FILE: Engines-Fuel  
Systems-Engine Electrical-  
Cooling (POWER PLANT-  
Engine Electrical)  
No. 1-13-82 Nov. 11, 1982

## TECHNICAL BULLETIN

An inoperative Cruise Command servo on 1981-82 Jeep vehicles may be due to a cracked or broken manifold vacuum hose connector on the servo.

Coolant Temperature and Intake  
Manifold Heater (EFE) Switch  
Locations in Intake Manifold

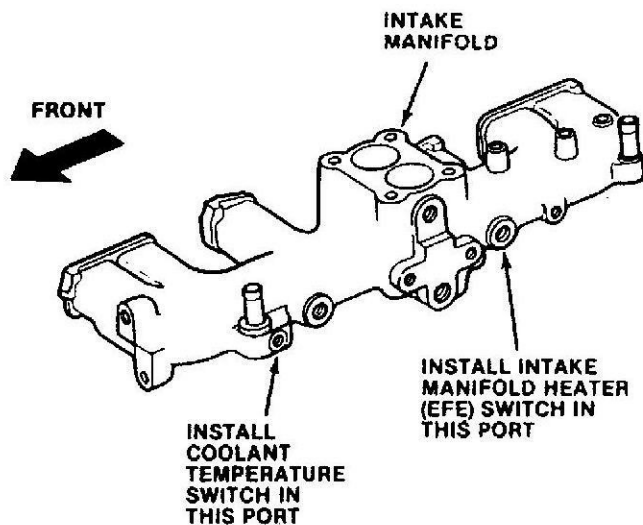
Service procedures and S.R.T. times for the new separate coolant temperature and intake manifold heater (EFE) control switches and wire harness adapter on 1982, six-cylinder Jeep models, with fuel feedback system built after February 18, 1982.

Whenever it is necessary to service the dual-function coolant temperature/intake manifold heater switch on models built prior to February 18, 1982, replace the original switch with the two new switches and harness adapters as outlined in the Procedure portion of this bulletin.

6. Apply a sealer such as Perfect Seal No. 5., Loctite 592, or equivalent to the threads of replacement intake manifold heater (EFE) control switch, 3242321, and install this switch in the rear port of the intake manifold. Tighten the switch to 20 foot-pounds (27 N·m) torque.

7. Apply a sealer such as Perfect Seal No. 5, Loctite 592, or equivalent, to the threads of replacement coolant temperature switch, 324 2318, and install this switch in the front port of the intake manifold. Tighten the switch to 20 foot-pounds (27 N·m) torque.

8. Connect wire harness adapter, 5763666 to the two switches and to the engine compartment wire harness. Route and secure the harness away from hot engine components or any linkage components.

**Alternator Bracket Lower Support Installation**

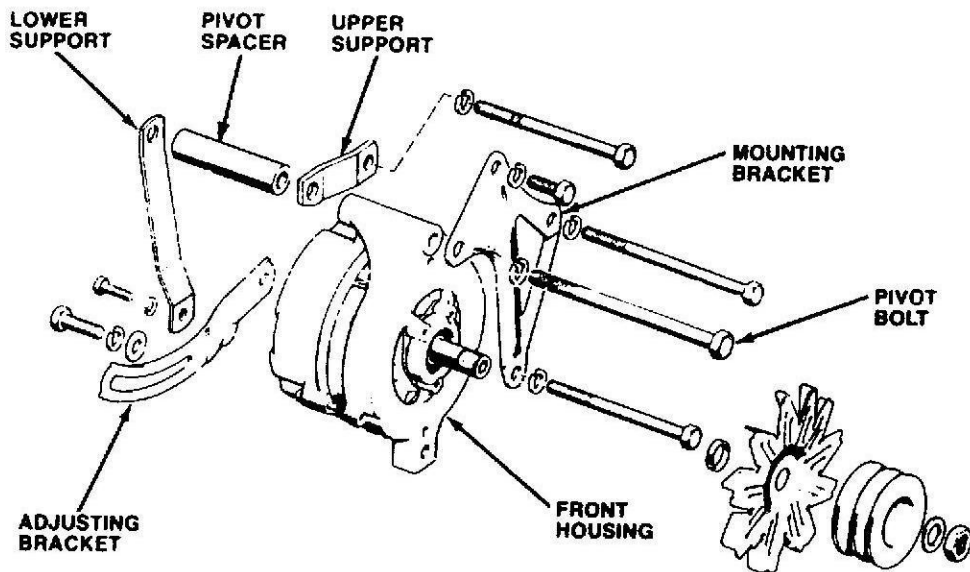
The front housing of some 70 and 85 amp alternators on 1981-82 Wagoneer, Cherokee, and Truck models with eight-cylinder engine and air conditioning may crack at the upper mounting boss and cause a vibration.

Replace the alternator front housing if necessary and install the following alternator bracket lower support to improve alternator mounting (see illustration).

8. Attach lower support 5364256 to the rear of the alternator with bolt 4200434 and lockwasher 4004807 (see illustration). Do not tighten the bolt completely at this time.

9. Position the alternator in the mounting bracket and install replacement pivot spacer 4006186 (see illustration).
10. Align the bolt holes in the alternator mounting bracket, front housing, upper and lower supports, and the pivot spacer, and install the alternator mounting bolt (see illustration).

**Securing Electronic Regulator**

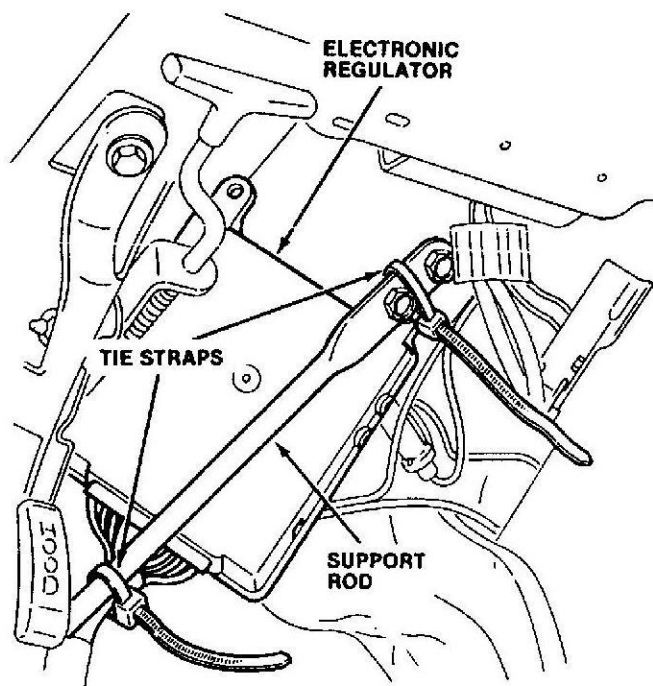
Whenever a Cruise Command malfunction occurs, first verify that the Cruise Command wire harness is properly connected to the electronic regulator before starting normal diagnosis and repair procedures. A poor connection can cause a complete or intermittent malfunction and is also the only non-testable connection in the circuit. This connection is disturbed whenever Test Tool AM PC-1-R is used. For this reason, a loose connection may be misdiagnosed as a regulator malfunction. Also, whenever an electronic regulator is replaced, it will be necessary to adjust the replacement regulator as outlined in this bulletin.

- (3) Secure the regulator to the lower end of the support rod by wrapping the tie strap around the regulator harness and rod (see illustration). Pull the strap tight to prevent the regulator from rotating.
- (4) Cut the ends off the tie straps approximately 1/2-inch away from the strap buckle.

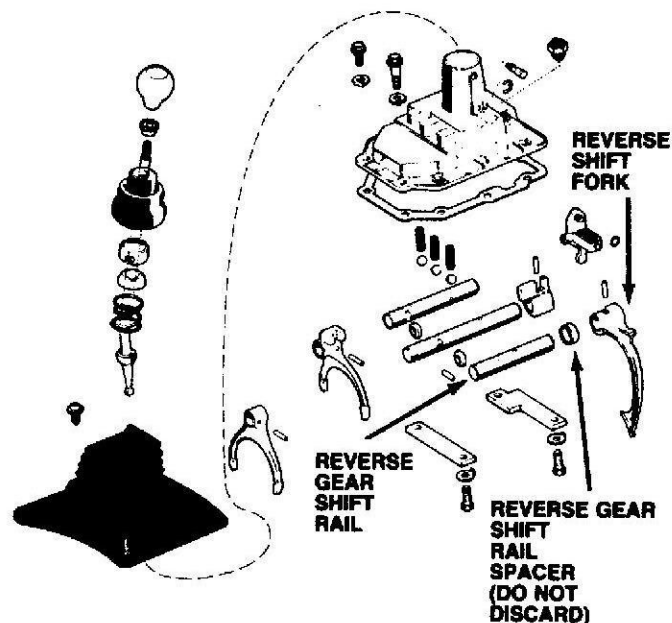
When servicing a 1981-82 T-176 transmission built after June 29, 1981, do not discard the spacer, part number 8134403, on the reverse gear shift rail (see illustration). This spacer was added to prevent reverse gear overtravel and must remain in place on the shift rail. Make a note of this information on pages 2B-22 and 2B-23 in the 1981 Jeep Technical Service Manual and pages 2B-33 and 2B-34 of the 1982 Jeep Technical Service Manual.

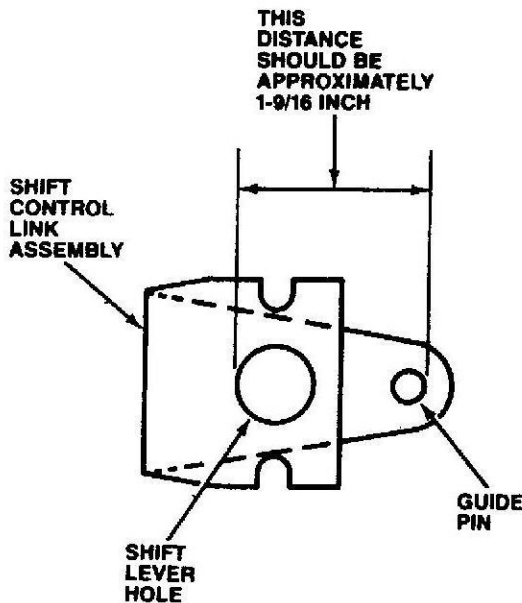
**CORRECTION:** Remove the shift control link assembly and measure the distance between the rear edge of the shift lever hole and the forward edge of the guide pin and replace the link assembly if this distance is other than 1-9/16 inch, (see illustration).

5. Using an accurate steel scale, measure the distance between the rear edge of the shift lever hole and the forward edge of the guide pin on the shift control link assembly (see illustration). The correct distance is approximately 1-9/16-inches.
  - a. If the distance measured is approximately 1-9/16-inches, and some type of shift problem occurred, further diagnosis is necessary. Refer to Chapter 2D in the appropriate Jeep Technical Service Manual for procedures.
  - b. If the distance measured is other than 1-9/16-inches, the link assembly is out of tolerance and must be replaced. Proceed to next step.

NOTE: Link assemblies that are out of tolerance will be from 1/16 to 1/8 inch over the correct distance.

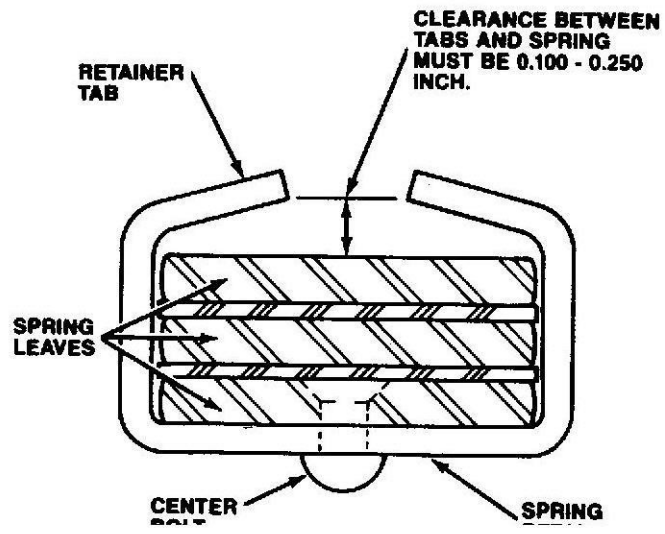
**CORRECTION:** Inspect the retainer tabs on each leaf spring and bend any tabs upward to provide the required clearance if necessary (see illustration).

Inspect the spring retainers and bend the retainer tabs upward as necessary to provide the required 0.100 - 0.250 inch (3 - 6mm) clearance as shown in the illustration.

Fig. 1 — Latch Assembly Inspection

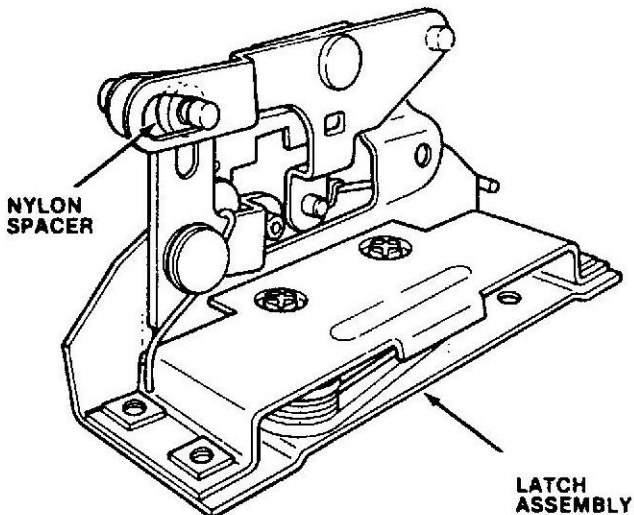
1. Remove the front door window regulator handle, door pull strap, and lower trim panel.
2. Inspect the latch assembly and control rods, and the J-shaped outside door handle rod and bushing.
  - a. Replace the latch assembly if damaged or if the nylon spacer between the lock and release levers, as shown in Figure 1, is damaged or missing.
  - b. If the latch control rod is bent or binding, it must be replaced. Do not attempt to straighten it.
  - c. Inspect the J-shaped outside door handle rod and bushing assembly. If it is bent or damaged, it must also be replaced. The rod must be equipped with a solid-type bushing as shown in Figure 2.

Fig. 3 — Lock Button Pivot Pin Retaining Clip Installation

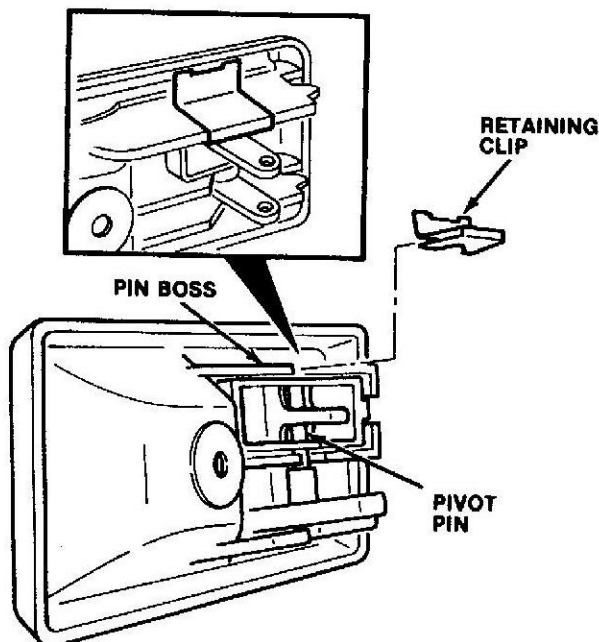
7. Install retaining clip, part number 4007207, over the remote control handle lock button pivot pin and pin boss (Fig. 3). Be sure the clip notch is fully seated on the plastic pin and pin boss.
8. Install the remote control handle in the door and install the handle retaining screw.
9. Install the door lower trim panel, door pull strap, and window regulator handle if not already installed.

Center Horn Button Cap Spoke  
Recess Modification

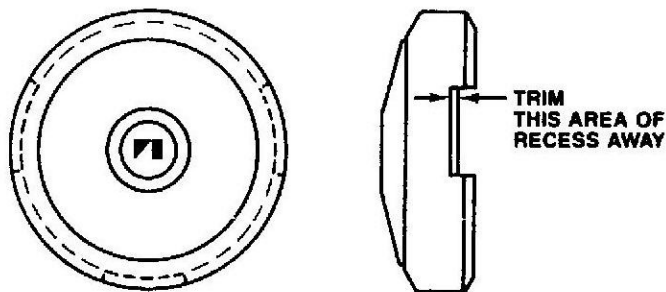
Check horn operation and inspect the cap for looseness as outlined in the following procedure and, if necessary, deepen the spoke recesses in the cap (see illustration) and replace the center horn button cap receiver if damaged.

3. Remove the center horn button cap.
  - a. If the horn did not operate at one or more of the spoke positions, deepen the spoke recess areas in the cap using a file or knife (see illustration). Trim the recess area down to the cap inner support only.
  - b. Inspect the horn button cap receiver for being bent or warped, especially around the retaining lip. If the receiver is damaged or if the cap was loose, replace the receiver as outlined in the following steps. If the receiver is not damaged and the cap was tight, proceed to step 7.
4. Disconnect the battery negative cable.
5. Remove the three screws that attach the center horn button receiver to the steering wheel hub and remove the receiver bushing and receiver.
6. Position replacement receiver 3242217 in the steering wheel hub and install the bushing and receiver attaching screws.

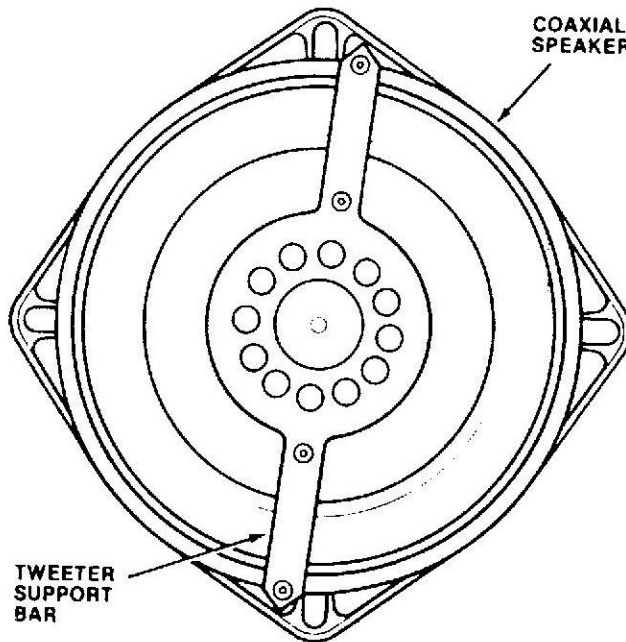
Inspect the radio speakers using a flashlight beam directed through the speaker grille to view each speaker and replace any speaker that is not a coaxial type (see illustration).

- (2) Replace any speaker that does not have a tweeter support bar mounted across the top of the speaker (see illustration). Coaxial speakers have a support bar, standard speakers do not.
- (3) Verify proper radio operation after speaker replacement.

Windshield Wiper Linkage Removal

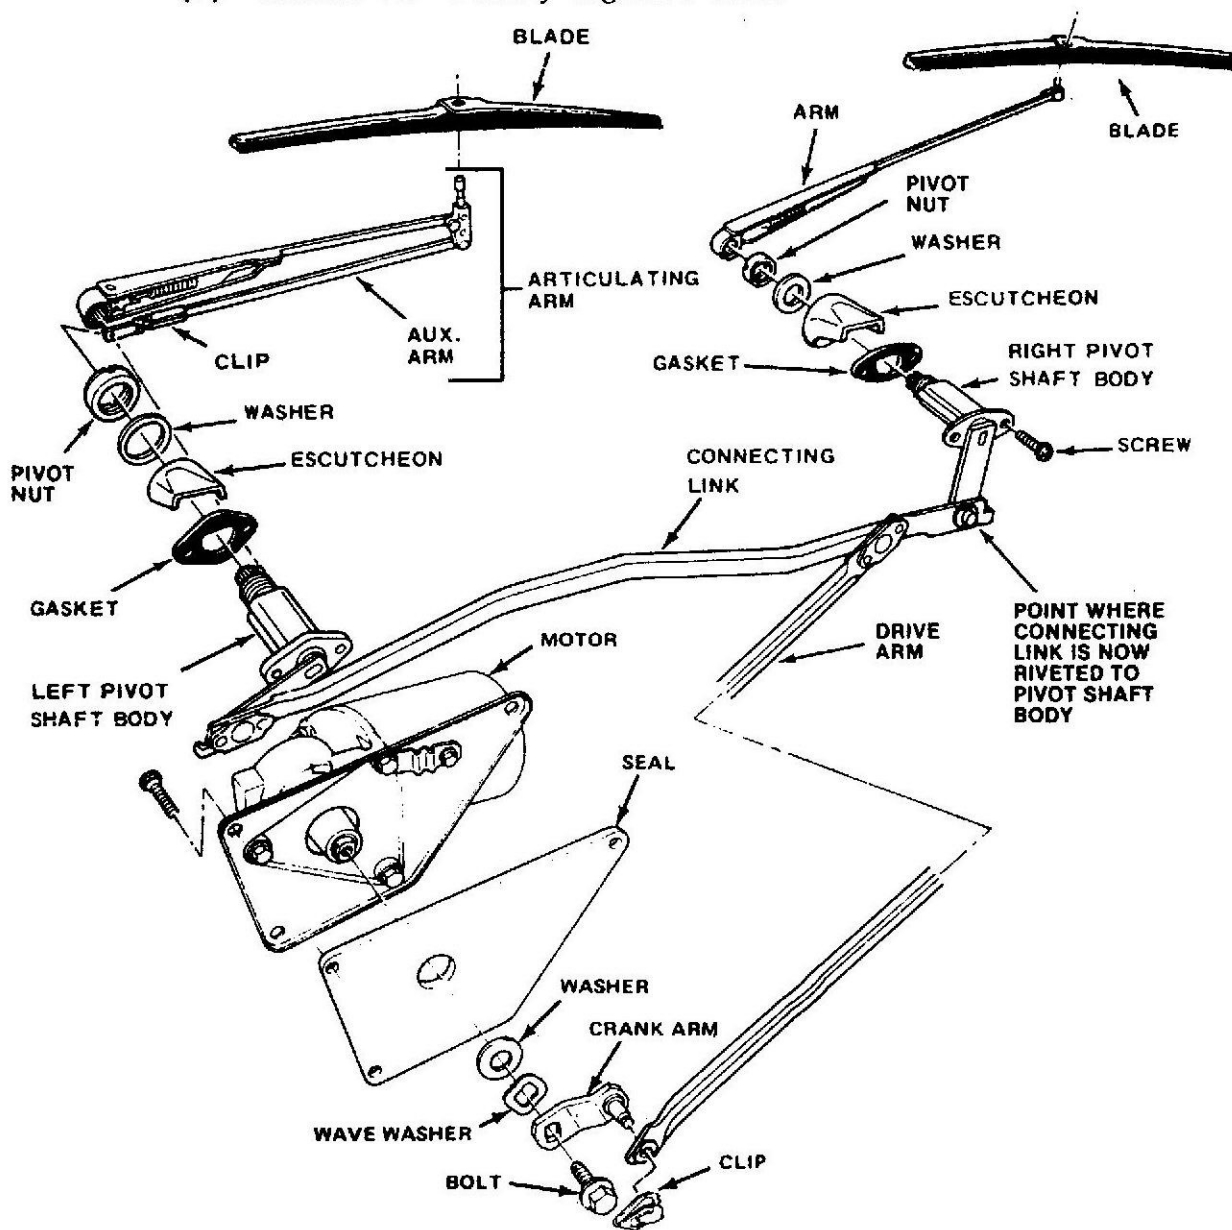
The connecting link is permanently attached to the right pivot shaft body and must be removed with the linkage as an assembly (see illustration). Make a note of this change on page 3T-5 of the 1981-82 Jeep Technical Service Manuals. The new procedures apply to models with or without air conditioning.

- (1) Disconnect the battery negative cable.
- (2) Remove the right and left wiper arms, pivot nuts, washers, escutcheons, and gaskets from the pivot shaft bodies (see illustration).
- (3) Remove the instrument cluster and the left defroster duct.
- (4) Disconnect the crank arm from the wiper motor.
- (5) Remove the glove box and the ash tray and slide assembly.
- (6) Remove the radio.
- (7) Remove the attaching screws from both pivot shaft bodies and remove the wiper linkage and both pivot shaft bodies as an assembly.

Spray Foam Hole Locations in Hardtop Inner Panel (Headliner) — Viewed From Passenger Compartment

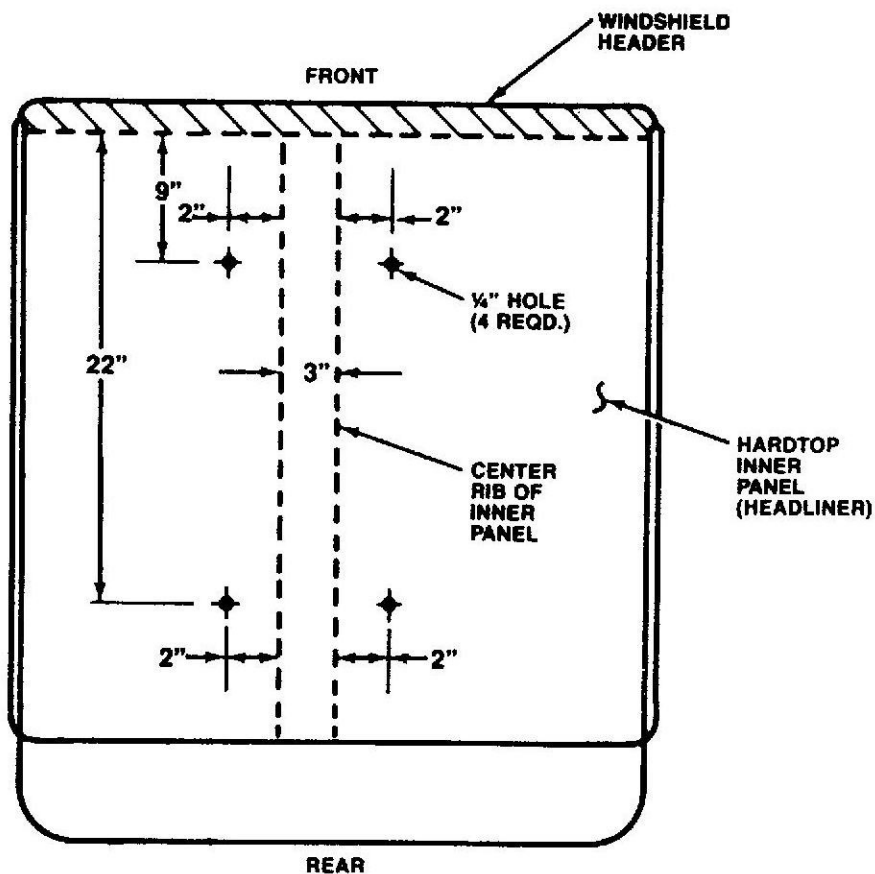
1. Locate, mark, and drill four 1/4-inch diameter holes in the hardtop inner panel (headliner). Refer to the illustration for hole locations.

2. Attach a three inch long section of 1/4 inch O.D. hose to the hose on the Touch-N-Foam can.
3. Insert the 1/4-inch O.D. hose into each hole drilled in the inner panel and spray foam into each hole for 45 seconds.
4. Install the button plugs in the drilled holes.
5. Allow the foam to cure 12 hours.

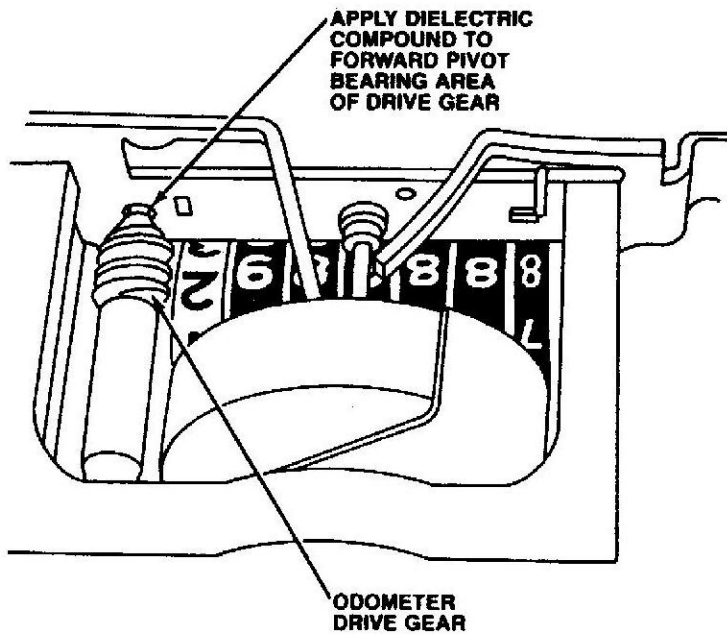
Remove the speedometer/odometer assembly and lubricate the forward pivot bearing area of the odometer drive gear with Dielectric Compound, 8126688 (see illustration).

1. Remove the speedometer/odometer assembly as outlined in Chapter 3C of the 1981-82 Jeep Technical Service Manuals.
2. Apply Dielectric Compound to the forward pivot bearing area of the odometer drive gear as follows: Rotate the odometer driven gear rearward slightly, lift the drive gear upward in its retaining slot, and work the compound into the pivot bearing area (see illustration)
